**FINAL
ENVIRONMENTAL ASSESSMENT AND
COASTAL ENGINEERING EVALUATION FOR
SHORELINE SETBACK VARIANCE APPLICATION**

TMK: 5-5-02:3
55-283 Kamehameha Highway
Laie, Oahu, Hawaii

Draft Environmental Assessment Review Comments and Response Letters

Project Name : Koki Seawall
File No. : 2004/ED-27
Tax Map Key : 5-5-2: 3
Subject : Response to Draft Environmental Assessment Comments

FIGURE 2-10. SHORE PROTECTION REVETMENT TYPICAL SECTION

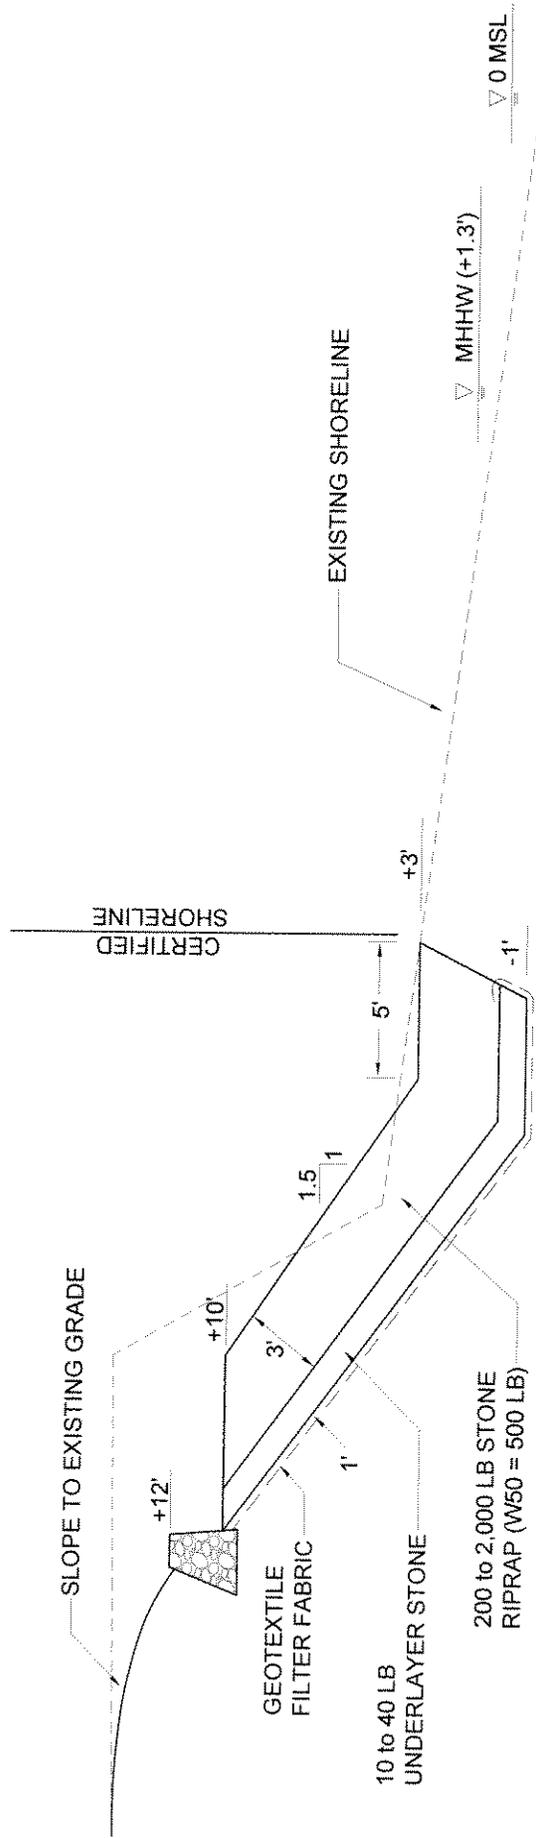
- 4) Page 8 of the Draft EA states that the toe elevation will be -1 foot below mean sea level (MSL) and the crest elevation will be +8 feet MSL (minimum). The Typical Section, Figure 2-8, shows the height of the revetment at +14. The Final EA should more definitively state the height of the proposed revetment. What is the elevation at the rear of the lot? If available, a topographic map should be provided. Figure 2-8 should identify the existing grade and any fill that might be added.

4. The minimum required revetment crest elevation to prevent overtopping by the design wave is +8 feet mean sea level (MSL). The existing top of the shoreline bank is approximately +14 to +16 feet, and the rear of the lot varies from +12 to +14 feet. In the Draft EA the project plan was shown with the revetment extended past the minimum necessary crest elevation in order to protect the bank all the way to the top. This plan has been modified, and now the proposed plan is to construct the sloping rock revetment up to a crest elevation of +10 feet, above and behind which will be constructed a 2-foot high CRM retaining wall to further stabilize the bank, and then the ground will be gently sloped back to existing grade along the width of the property. A topographic map has been added to the Final EA, and the EA has been revised to explain the proposed project plan in more detail.

7. The Application for Shoreline Setback Variance dated September 2, 2004, included a design analysis for the revetment stamped by a licensed professional engineer. This analysis included a typical cross-section drawing for the revetment. A revised design analysis will be submitted with the Final EA which also includes a plan view drawing of the proposed revetment.
